ISSUE: Certificate of Appropriateness for alterations

LOCATION: Old and Historic Alexandria District
203 South West Street

STAFF RECOMMENDATION

Staff recommends approval of the Certificate of Appropriateness for solar panels, as submitted.

Photo 3: Roof plan of proposed solar panels.

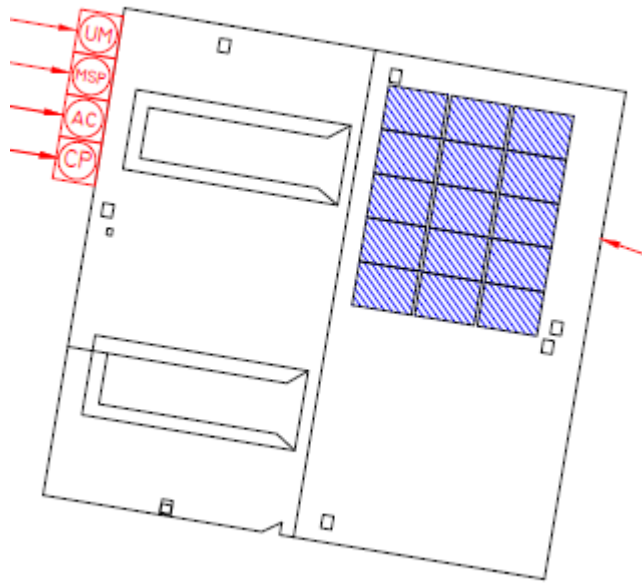
Although the configuration of the panels is consistent with the *Design Guidelines*, the panels will be visible from the street which is discouraged by the *Design Guidelines*. While the Design Guidelines discourage solar panels on a street-facing roof slope, staff supports the installation of the panels in this instance, given that the townhouse is a later building and located more than 15 feet from the front property line and installation will not remove or damage any historic fabric. The utility meter and other mechanical connections relating to the solar panels will be located on the rear elevation and will not be visible from the public street. However, mounting the solar panels to the rear elevation, would not provide the panels with the necessary amount of sun exposure and the roof surface is broken by a large dormer. Staff notes that if the property were in the Parker-Gray district, staff could administratively approve the solar panels on the front (street facing) elevation because of the building's age and location on the site.

Solar panels are closely related to the installation of dormers in regard to how an architectural feature should be installed on an existing building. The *Design Guidelines* state that "...dormers should match the existing proportions of the building and the windows and should be aligned with the existing windows or be centered between the windows". The proposed panels will be installed over one of the two window bays, creating an asymmetric roof profile. However, the townhouse is located in a row of adjoining townhouses with jagged rooflines and the installation of the solar panels will not disturb the overall composition of the rooflines on the blockface.

While solar contractors often recommend that roofing be replaced prior to installing the panels, so that they do not have to be removed and reinstalled a short time later, the property owner in this case has indicated that the existing roofing is in good condition and will not be replaced before the panels are installed. The current brown-colored composition shingle roof is generally discouraged

by the *Design Guidelines*, and staff notes that the proposed solar panels would be less visible if the composition shingle roofing were in the appropriate weathered wood or slate blend colors. Neighboring properties have been replacing original roofs with a composition shingle roof in the appropriate color, and staff encourages the property owner to install an appropriate color shingle roof when it is time to replace the roof so that the solar panels visually blend-in with the roof.

In summary, the installation of solar panels on this later building will provide significant benefits with minimal alterations to the property while being compatible with adjacent historic resources and the overall district. Staff believes that this building is ideal for this particular application given the location of the townhouse set back on the site, the later age of the building, and how minimally invasive the installation will be to the existing roofing. The proposal has been very sensitively designed with the solar panels only covering 20% of the existing roof and minimally impacting the roofing composition of the row of townhouses. Staff recommends approval of the project, as submitted.
